Technical Bulletin T753

Hardware Technical Bulletin: T753-H2004-03

Subject: HDTV Component
Video change

Figure1

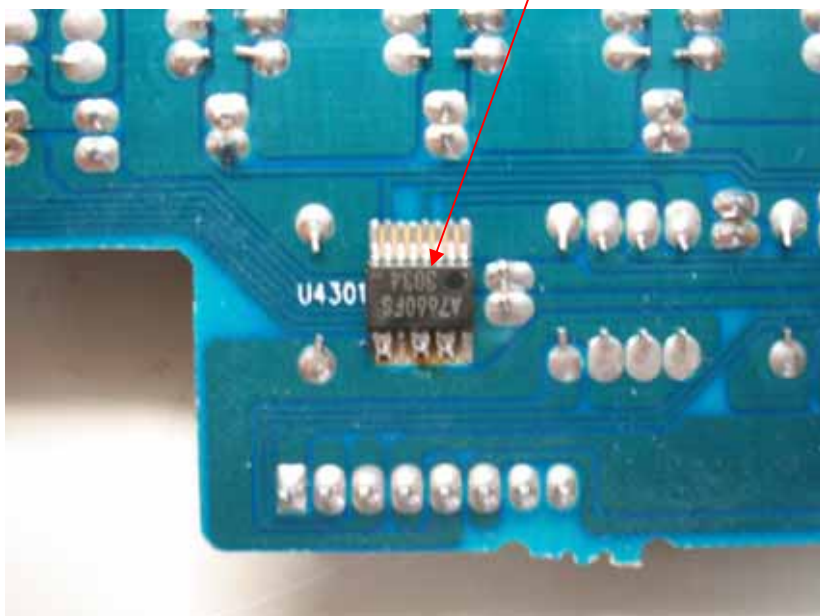
REASON: When decoding HDTV signals some TV/Monitors may experience horizontal sync loss.

On the component video PCB U4301

- A) Link the following pins on U4301;
- Pins 9 to 10
 - Pins 12 to 13
 - Pins 14 to 15
